APPLICATION NO.	FILING DATE	FIRST NAMED INVENTOR	ATTORNEY DOCKET NO.	CONFIRMATION NO.
10/720,099	11/25/2003	Roberto Amaduzzi	2537-1010	4473

Office Action Summary	Application No. 10/720,099	Applicant(s) AMADUZZI, ROBERTO	
	Examiner Davis D. Hwu	Art Unit 3752

DETAILED ACTION

Fig.2

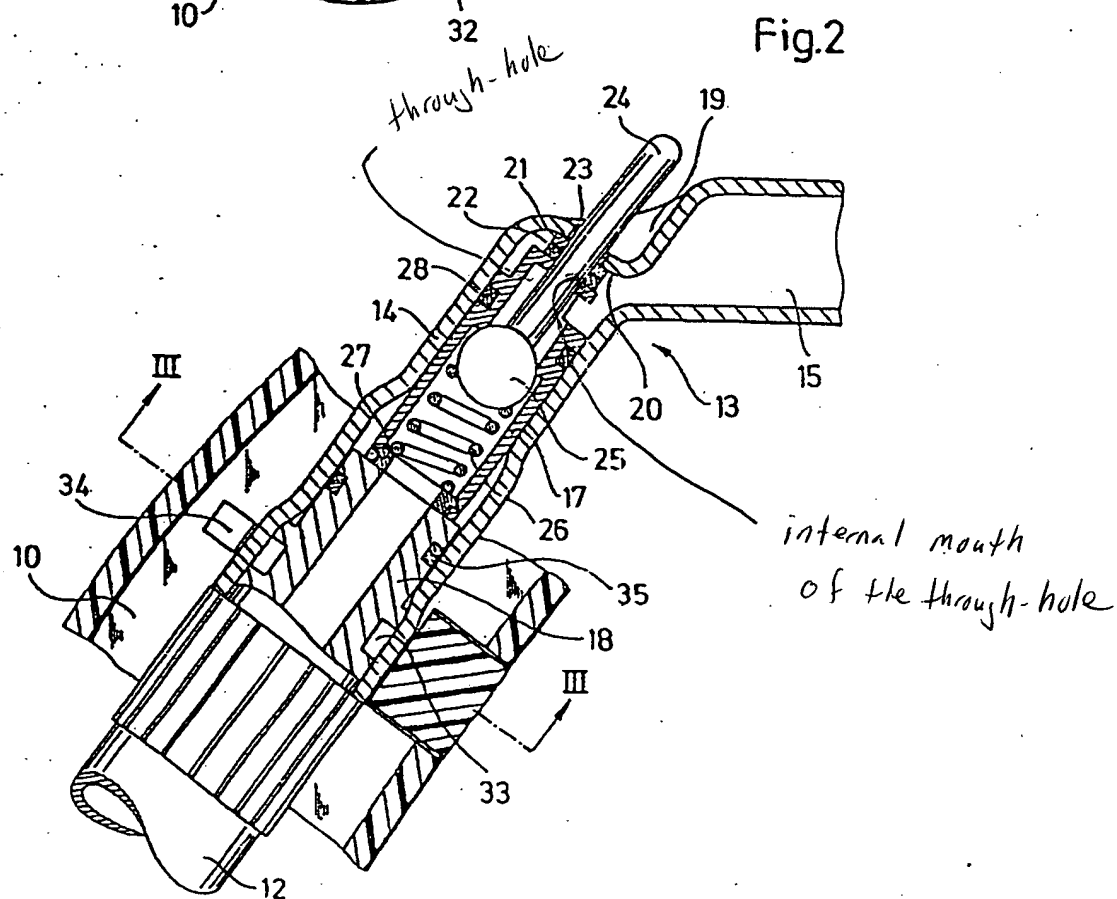
Suttner shows an intercept valve of a high-pressure spray washing gun, the valve comprising a main body 17 having a tubular conformation, an obturator 25 arranged internally of the main body and mobile as recited, an annular seating for the obturator housed in the main body, an activating pivot 24 of the obturator which is internally slidable in a through-hole in the main body, means 11 or maneuvering which act on the pivot 24, at least one seal 22 arranged at the through-hole about the activating pivot 24, wherein the seal is at least one lip seal contacting against the activating pivot an arranged adjacent to an internal mouth of the through-hole in the main body (see figure 2 included herein).
